**Bridge Factors Factual Report Attachment 29 – Email from Mr. Rodrigo Isaza of MCM to
Mr. Dwight Dempsey of FIGG dated March 14, 2018**

Miami, FL

HWY18MH009

From: Rodrigo Isaza [REDACTED]
Sent: Wednesday, March 14, 2018 1:38 PM
To: Dempsey, Dwight
Cc: Hango, Erika N.; Ernie Hernandez; Pedro Cortes; Pate, Denney; Figg, Linda; Hines, Franklin; Leon, Eddy D.; Phipps, Alan; DeHaven, Tom
Subject: RE: FIU-UCPP - Stage 3 - Erection of Main Span
Attachments: [REDACTED] sent you files via WeTransfer; 20180313-Crack gauge on back left.jpg; 20180313-Crack gauge on back right.jpg; 20180313-Crack on front of Diaphragm.jpg; 20180313-New Shim front and under.jpg; 20180313-New Shim front view.jpg; 20180313- Cracks on back left.jpg; 20180313- New Shim back view.jpg; 20180313_163553_resized.jpg

10' 3/13/18
5:00pm

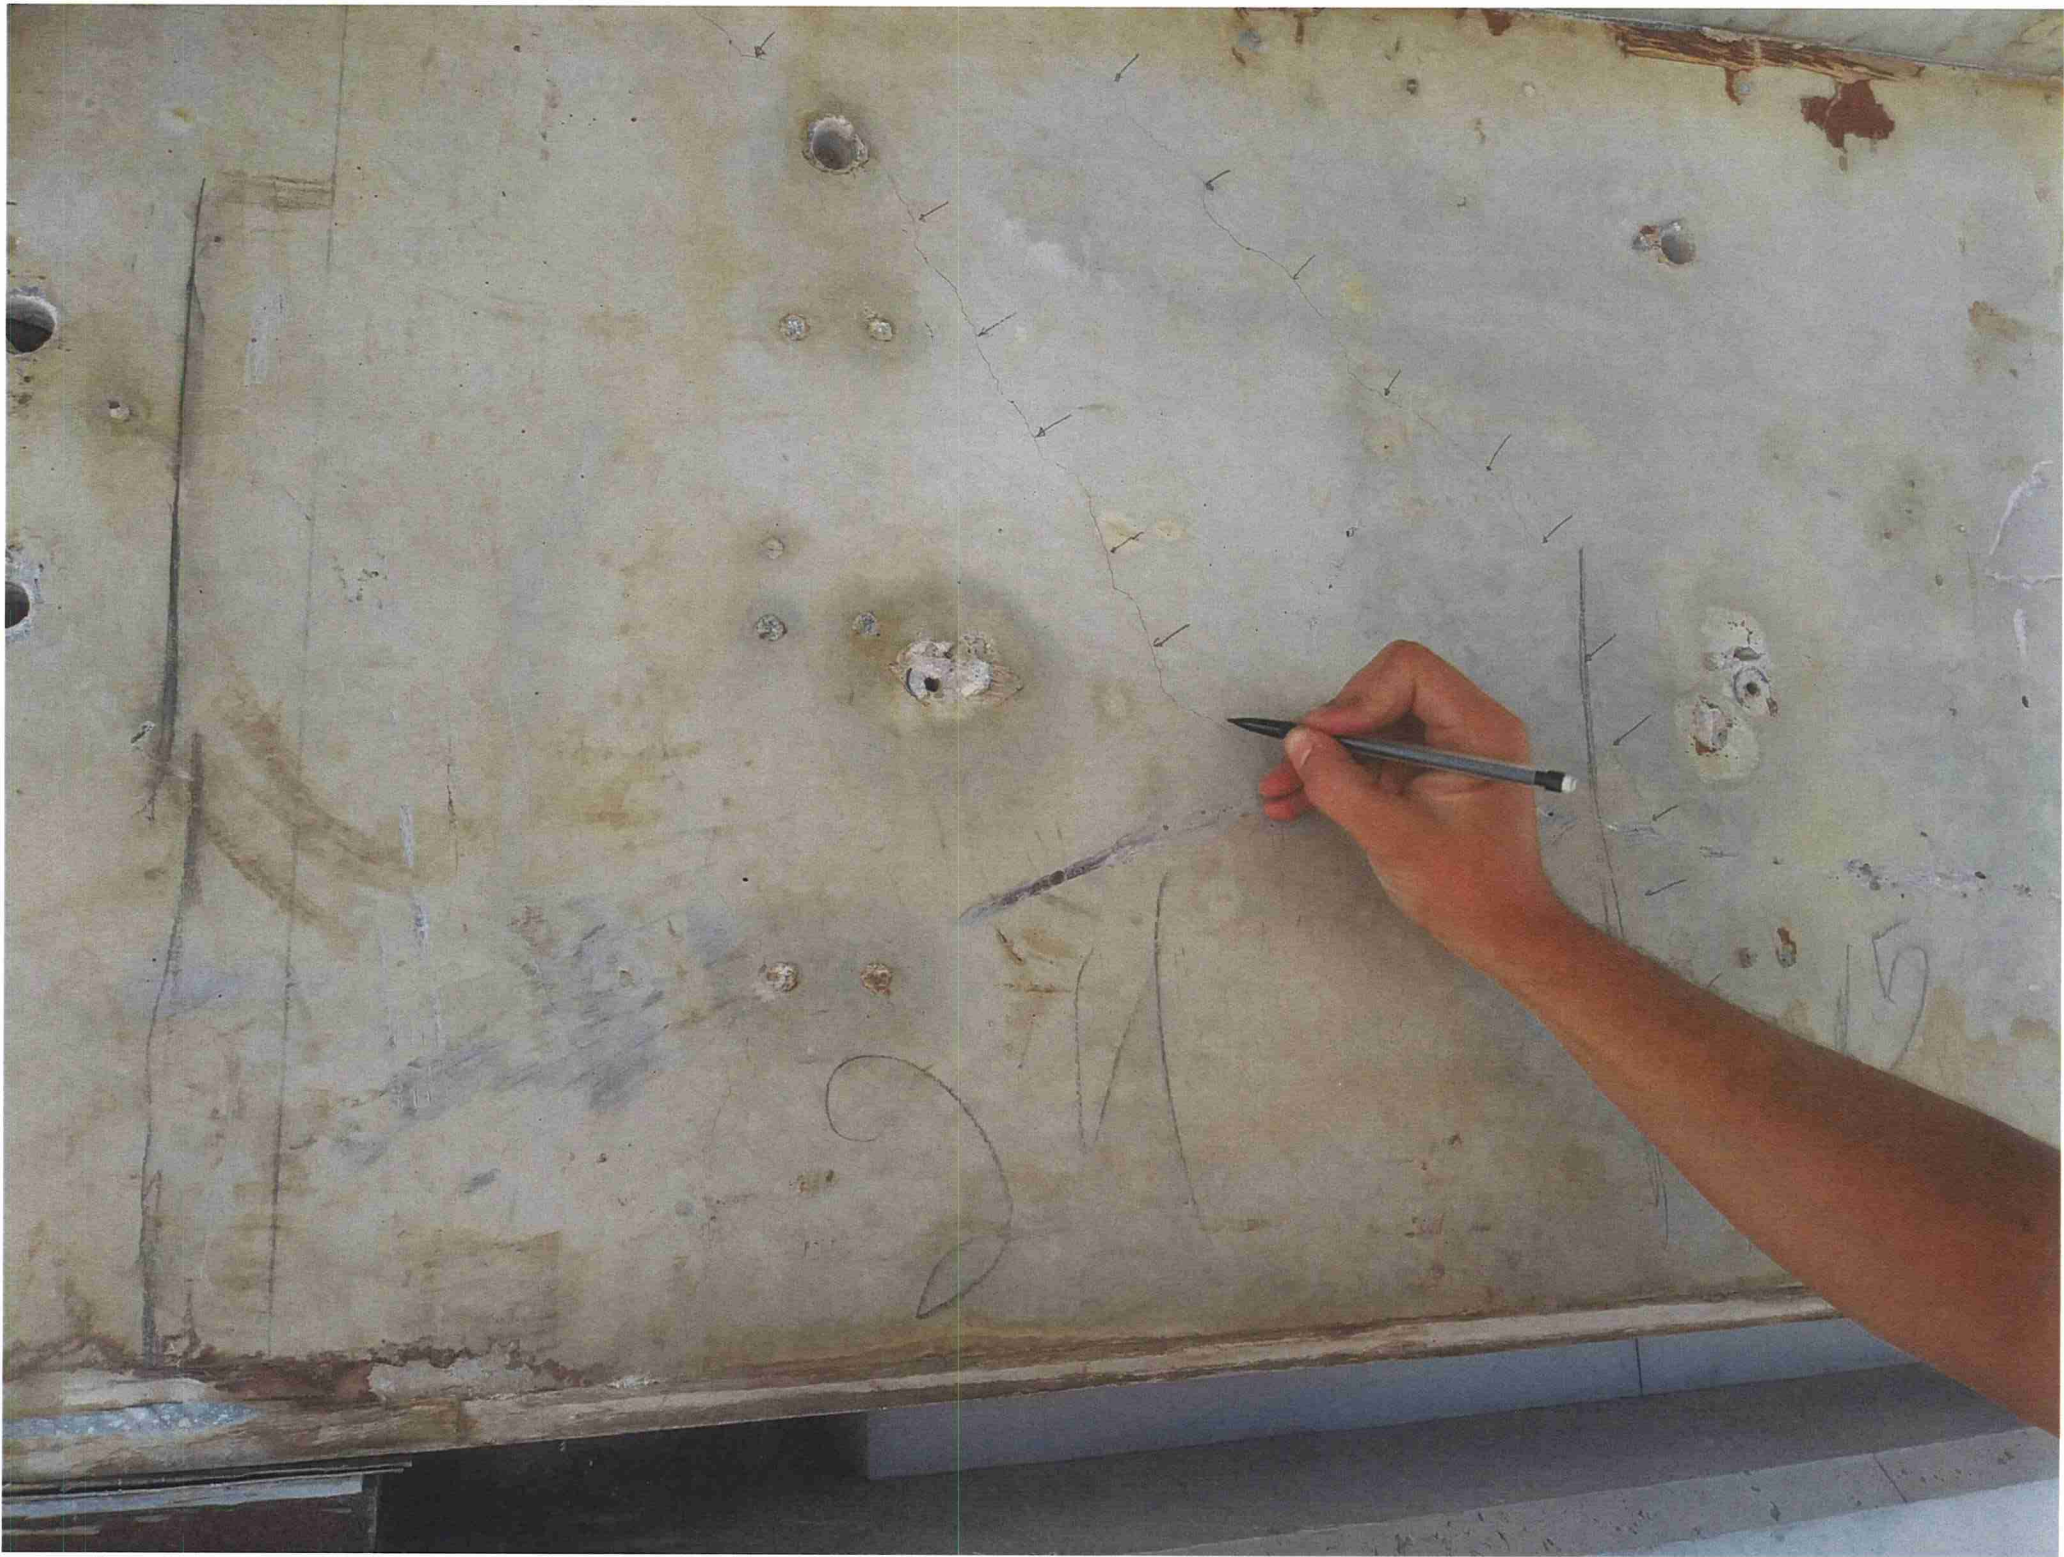
As you and I just discussed, Figg is evaluating this situation as a top priority and will be making recommendations as a result of this evaluation. As of right now, we do not see this as a safety issue but we do recommend that MCM place plastic shims (same as currently being used) underneath the Type 2 diaphragm at the centerline of bridge (this is a 2'-10.5" x 21" area). The shim stack height should be sized to bear against both the top of lower pylon and the bottom of the type 2 diaphragm. Below is a list of facts and other coordination items from our discussion;

1. MCM observed cracks in the Type 2 diaphragm on Saturday afternoon after the SPMT were driven back to the staging area and before the temporary pt bars were destressed. It was noted that Figg Inspection of the main span in this area after the bridge move did not observe this behavior. It is not clear as to when this behavior occurred.

4. This behavior is only being observed on the north face of the type 2 diaphragm. It is not seen on the south face. MCM to send Figg pictures of the south face of the Type 2 diaphragm and label pictures.

6. MCM is to place plastic shims under the Type 2 diaphragm/vertical strut. This is a 2'-10.5" x 21" area to be shimmed. Shims to be placed tight against the top of lower pylon and bottom of type 2 diaphragm. No jacking of bridge is required. These shims need to be placed right away.

4. We understand that MCM is currently placing the shims under the Type 2 diaphragm at the centerline of bridge and will send pictures once complete. MCM will also send pictures of the existing shim stacks to show orientation of shim stack to Type 2 diaphragm. **Shims were installed yesterday (see photos attached; however, if these are consider temporary, we may need to jack to get them out. We can discuss it further with your team tomorrow inclusive of the grout on this area.**
